S9574TM

HEAD, DRILLED, PD SHANK, SILVER PLATED, CORROSION AND HEAT RESISTANT STEEL, UNS S66286, 130 KSI MIN, .1900-32 UNJF-3A

SHEET 1 OF 2

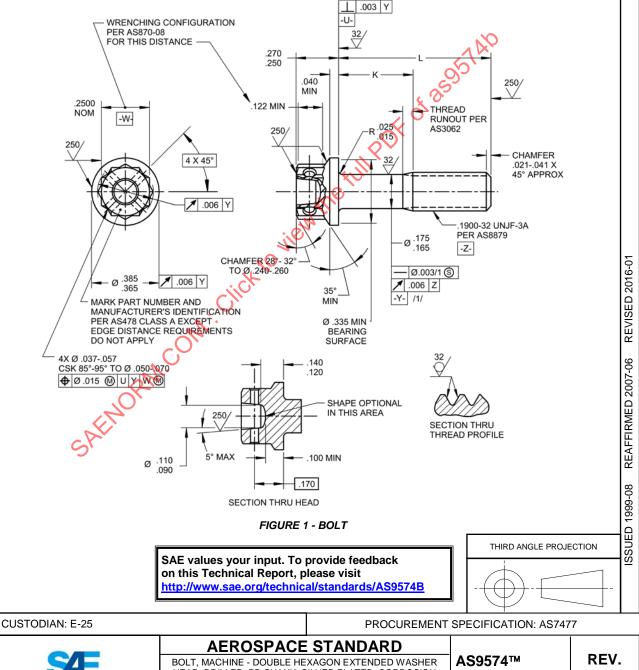
UPDATE THREAD SPECIFICATION TO AS8879, ADD OPTIONAL SHAPE FOR BOTTOM OF LIGHTENING HOLE, ADD TERTIARY DATUM FOR POSITION OF SAFETY WIRE HOLE, RELOCATE RUNOUT REQUIREMENT ON BOLT HEAD TO ACROSS POINTS, DELETE RADIUS REQUIREMENT AT TRANSITION FROM WRENCH PAD TO BASE FLANGE, ADD MINIMUM SENSITIVITY LEVEL TO DRAWING NOTE 5, ADD DATUM NOTE 1 FOR SHORT BOLT LENGTHS, RELOCATE DATUM W AND GENERAL EDITORIAL UPDATE.
